# Product Modification Notice

## #17-CORP-03

Date: 10/04/2017  
To: Lumenera Customers  
From: Lumenera Corporation, Product Management  
Re: **IR/AR Filter Upgrade in Lumenera's Lm11059C Camera Models**

### **IR/AR Transmission Values**

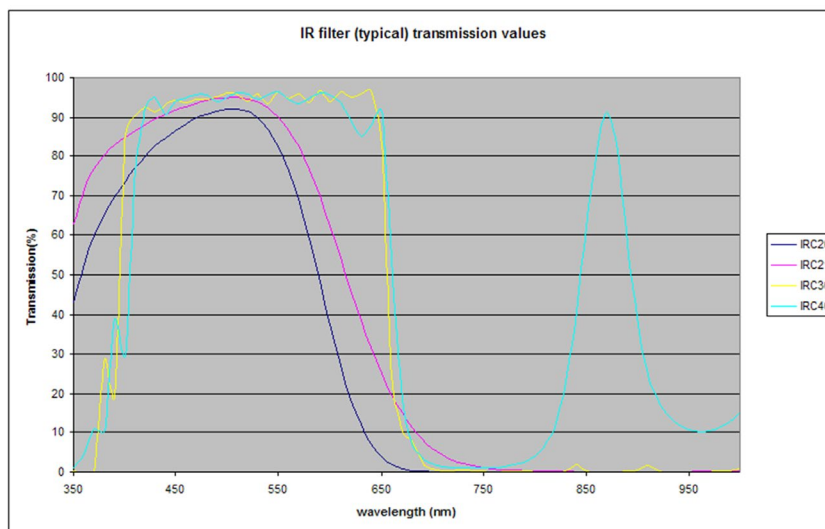
Currently these models only have an **IR** coating, and we will be transitioning to a new filter that has an **IR/AR** coating. This filter change will improve the camera's sensitivity, with an approximate 5% increase in transmittance.

REFER TO **IRC30** PLOT
